# MAIN STREET TOWNHOUSES

83 MAIN ST, NETCONG NJ 07857

**TITLE SHEET,  
ZONING CHART &  
INFORMATION,  
MAPS, DRAWING  
LIST**

## FLOOR TRANSITION SCHEDULE

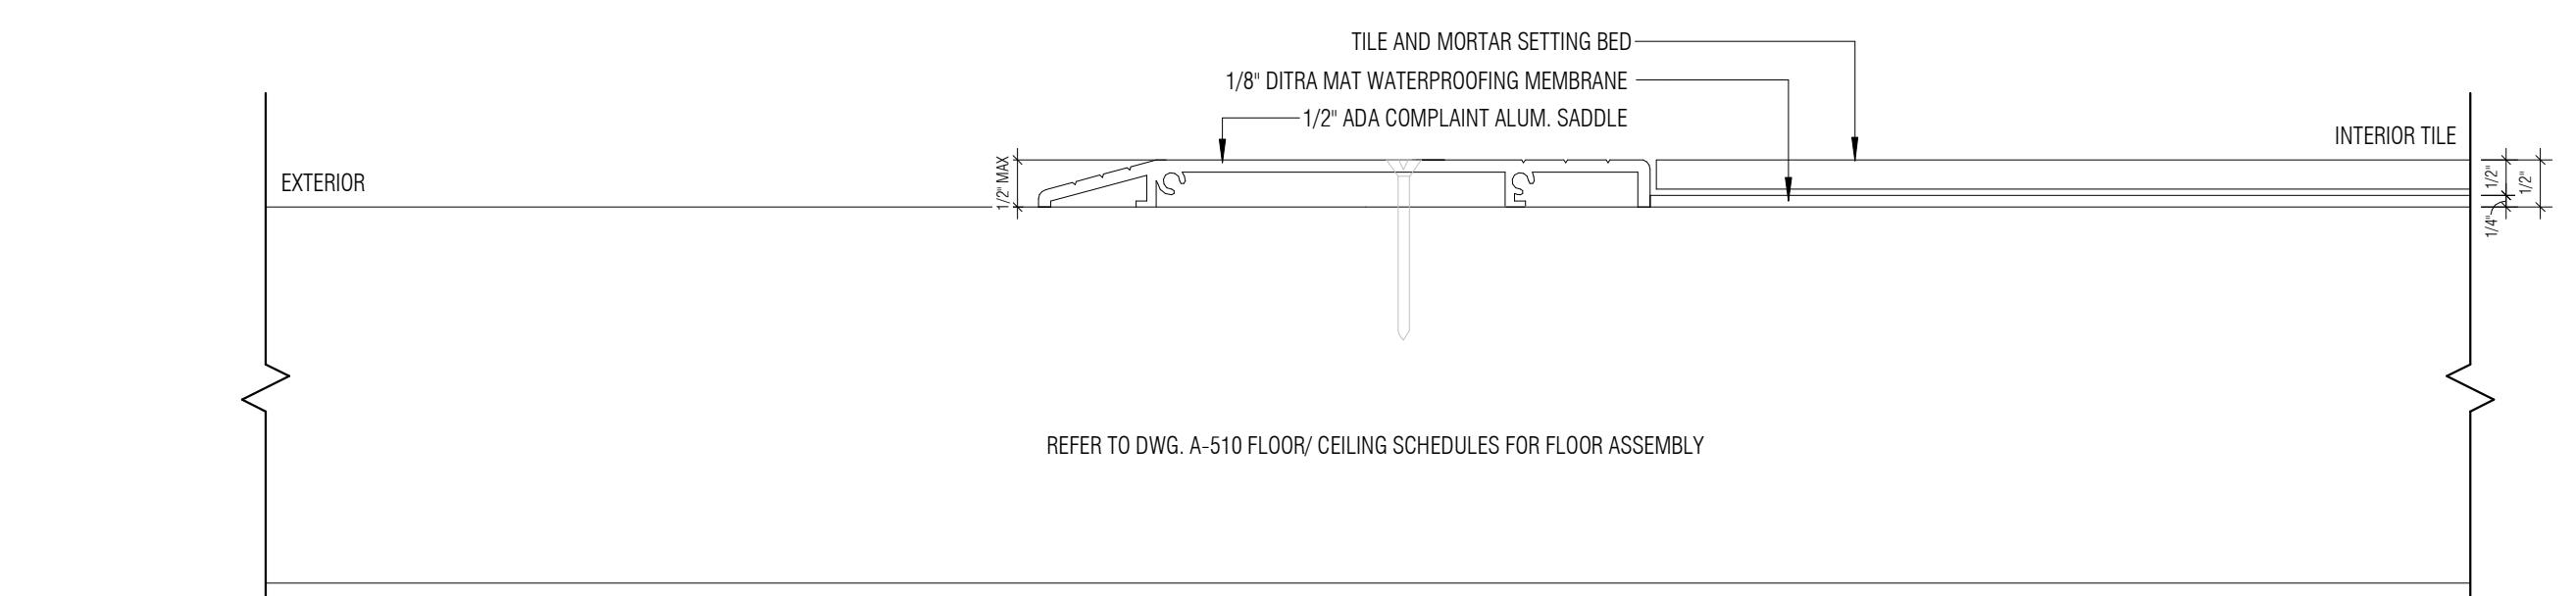
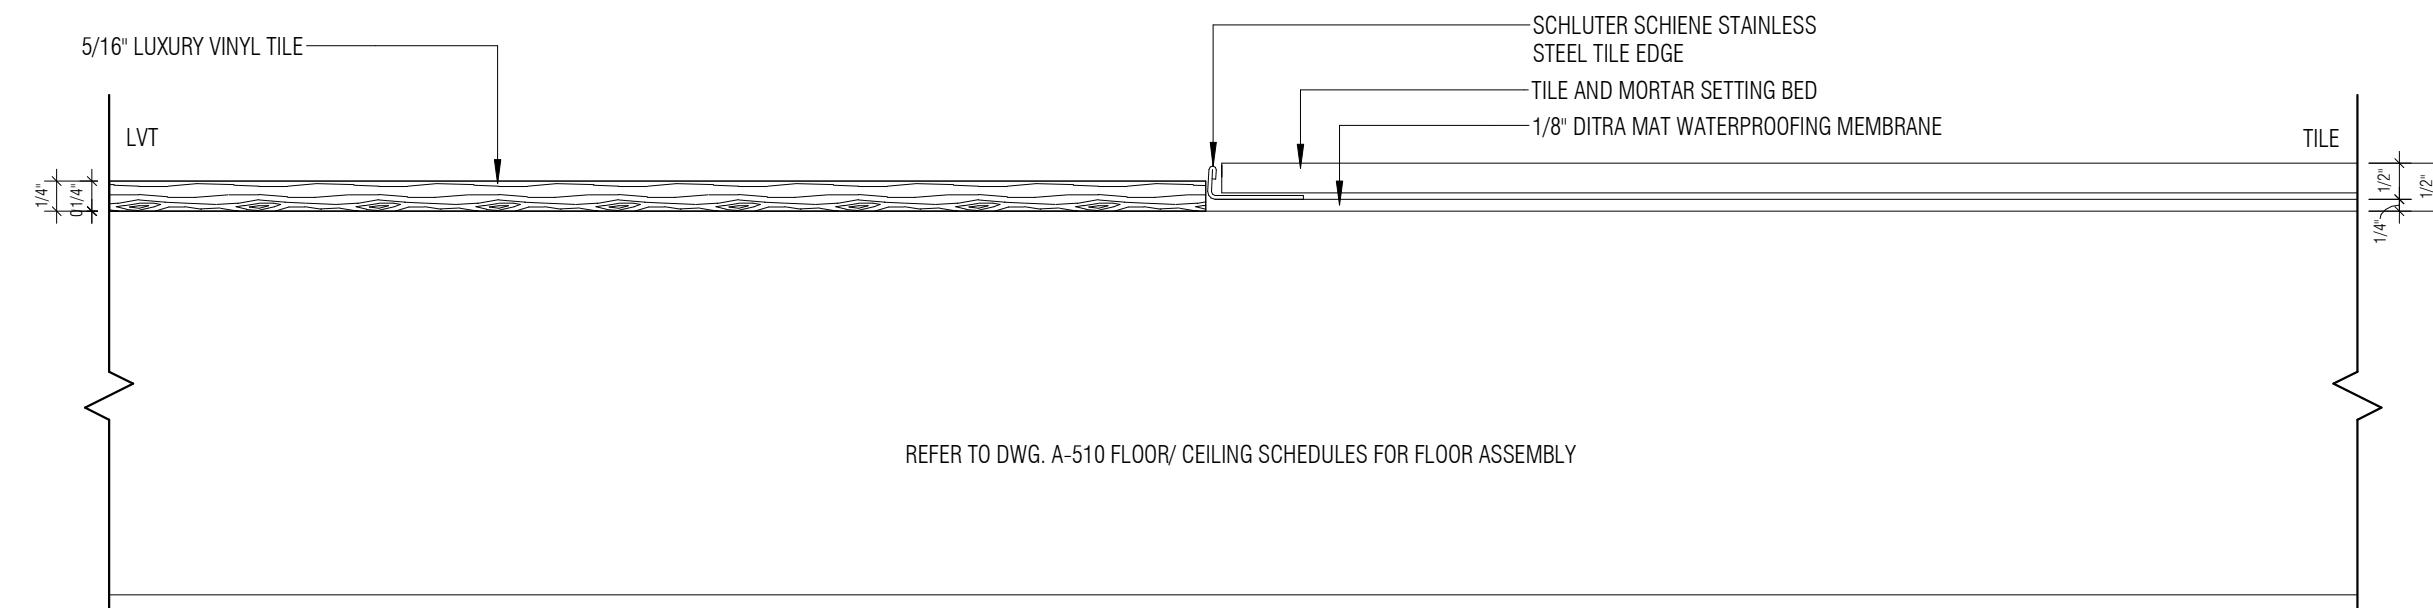
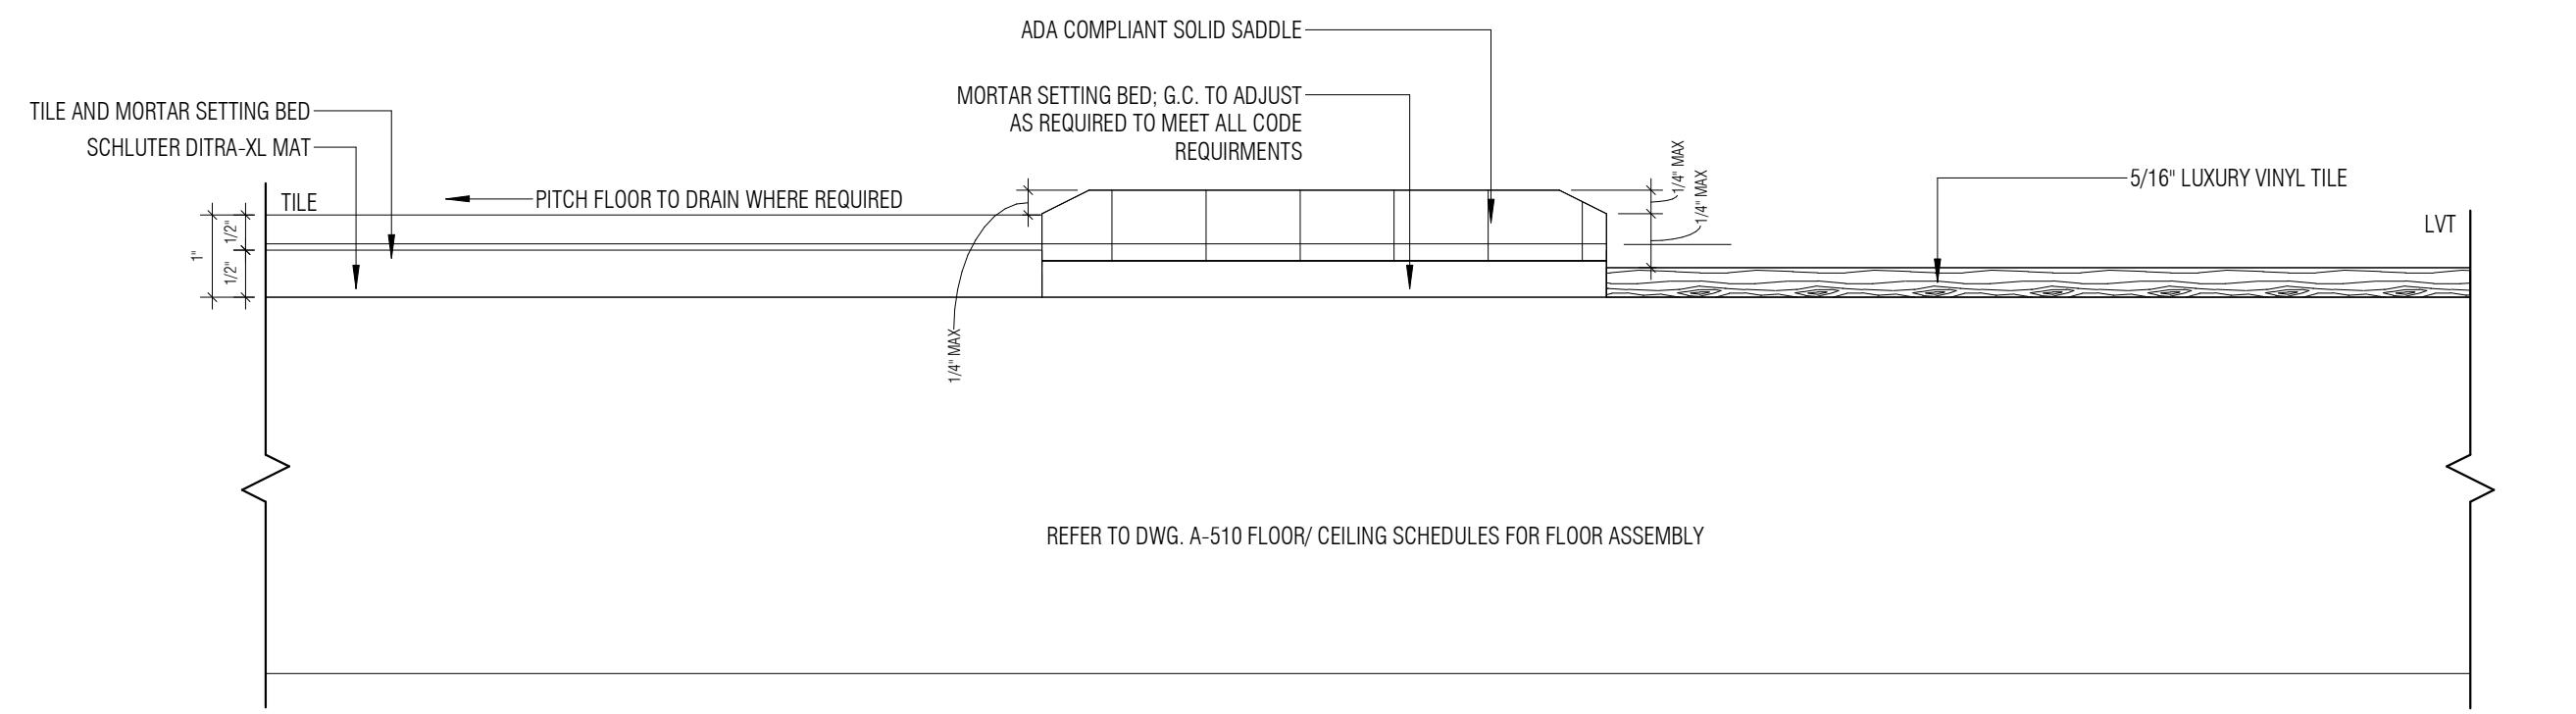
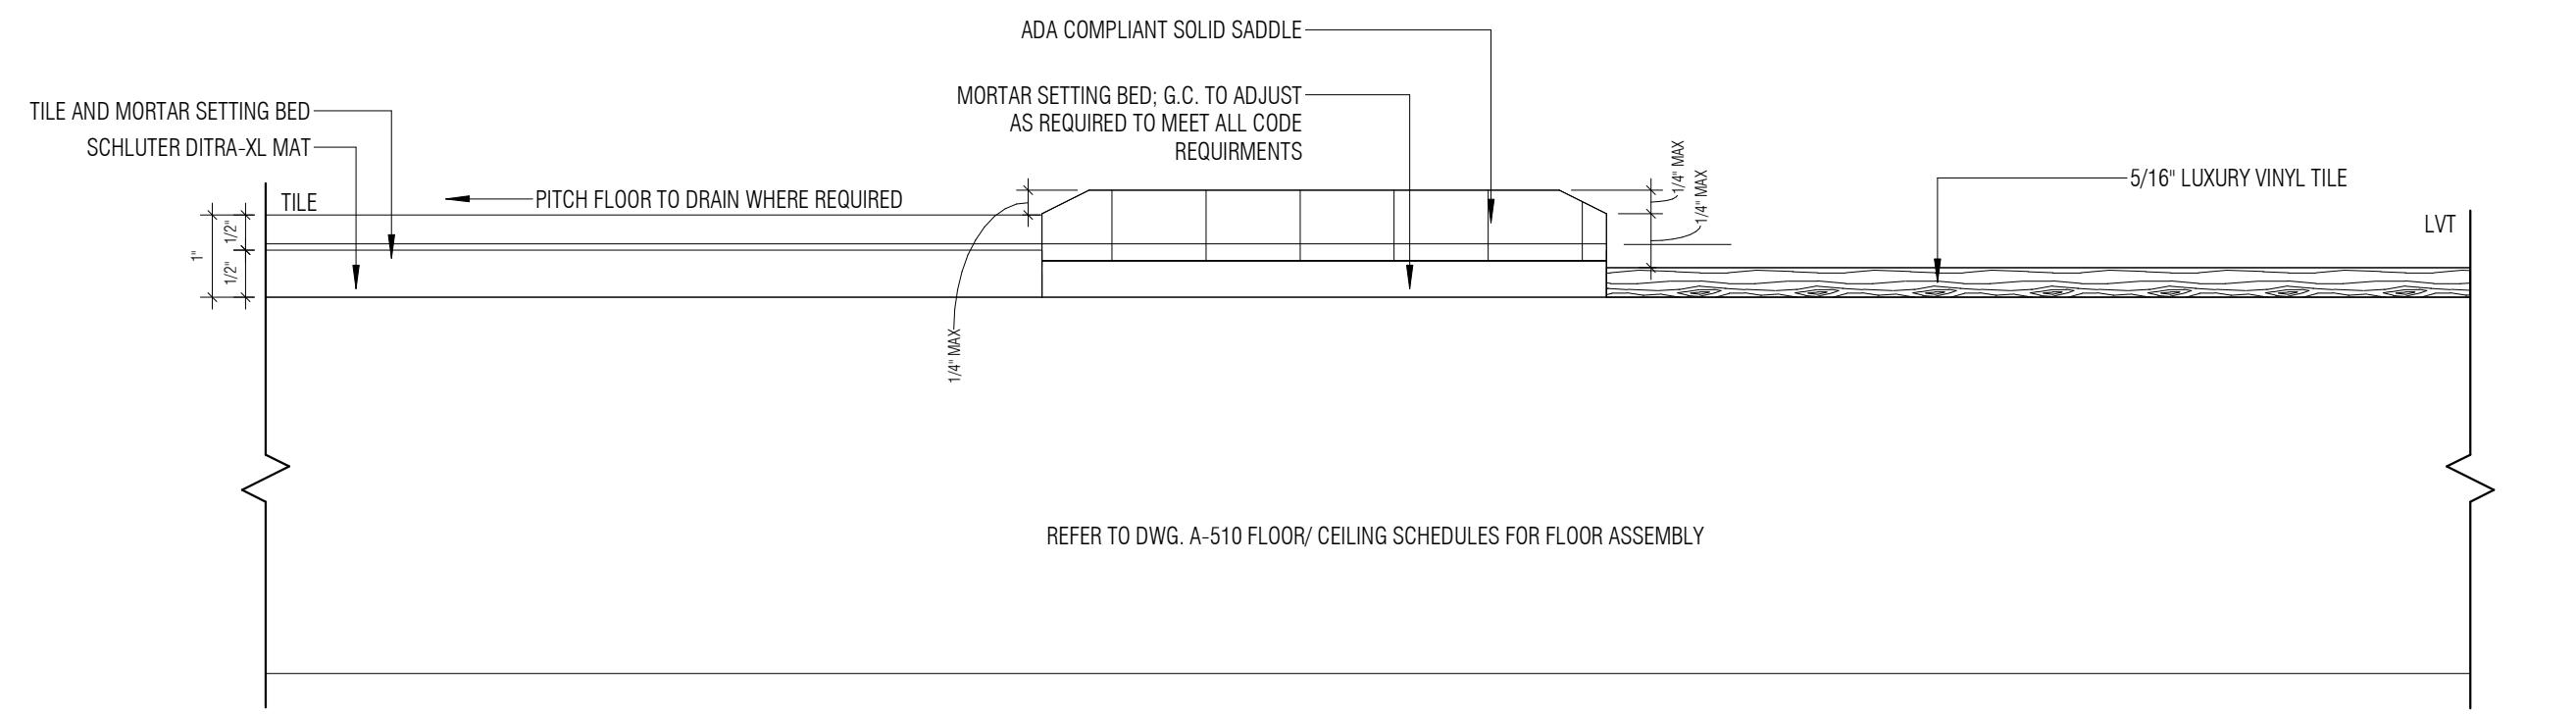
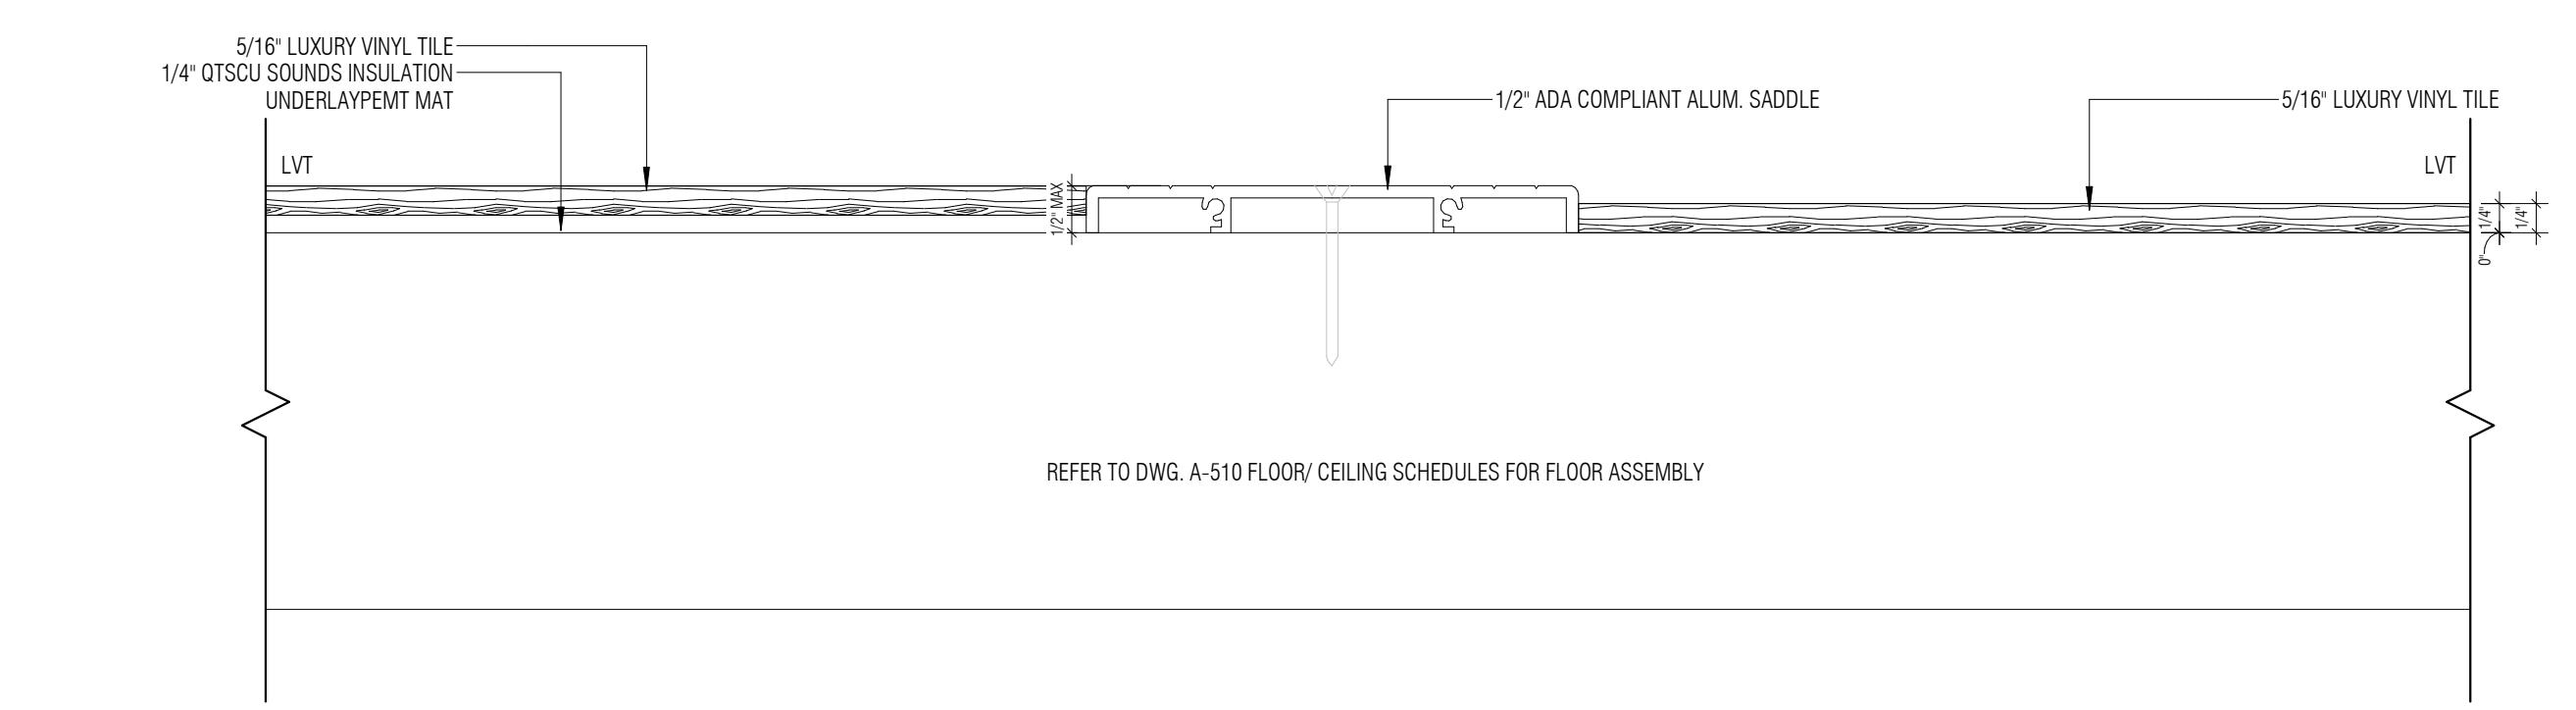
WHAT TYPE OF FLOOR FINISH ARE WE PROPOSING? I DON'T THINK WE NEED ALL OF THESE. PLEASE ADVISE.
